Report title:	Designers response to Stage 1 Road Safety Audit, A49 / Cromwell Avenue Roundabout, Warrington
Date:	5 th February 2021
Document reference and revision:	1901/RSA/DR/02
Prepared by:	Highgate Transportation Ltd
On behalf of:	Satnam Millennium Ltd

A Stage 1 Road Safety Audit (ref: RSC/KS/EB/20044) was undertaken by Road Safety Consulting Ltd on 29th January 2021 with regard to proposed capacity improvements at the A49/Cromwell Avenue roundabout, Warrington. The proposals include the lengthening and widening of the A49 northbound left turn lane to A574 Cromwell Avenue, including the relocation of a bus stop and offset of pedestrian footway.

Google Earth screenshot of A49 northern approach road markings:

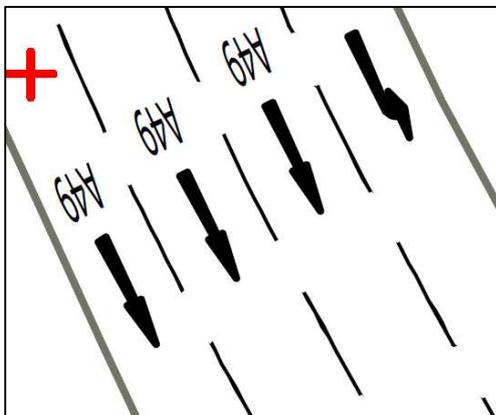
Description	Recommendation	Design organisation response	Overseeing Organisation response	Agreed action	RSA
4. On the northern approach arm of the junction, drawing 27 shows the offside lane as "A49". This is assumed to be a drafting error, as the existing marking shows "A574".	The lane allocation marking on the drawing should reflect the existing situation.	This was a drafting error and will be updated at detailed design stage.
